Delegated Report

Reserved Matters Planning Application

Planning Application No: 20230537

Location: 1 Foxbury Manor Old Watling Street Higham Rochester

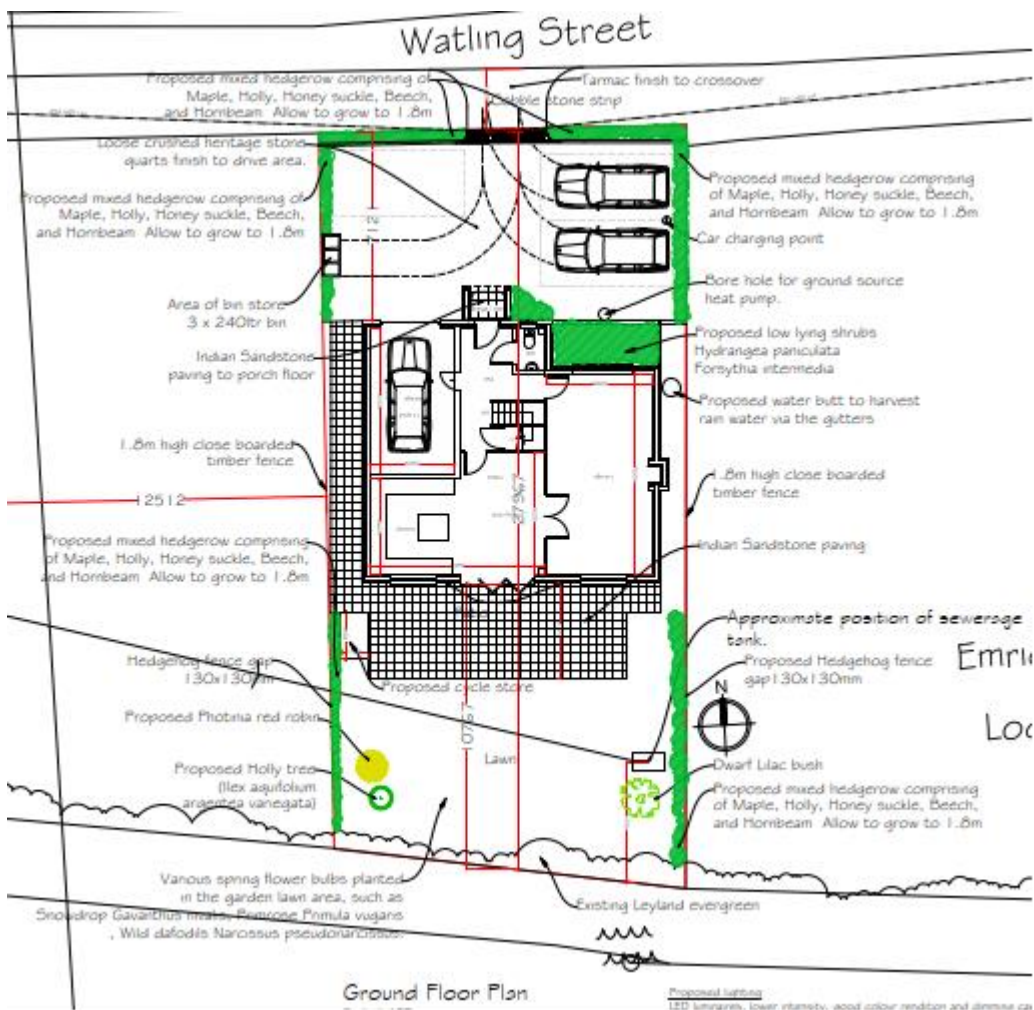
The outline approved site layout shows one house with parking and access from Watling Street:
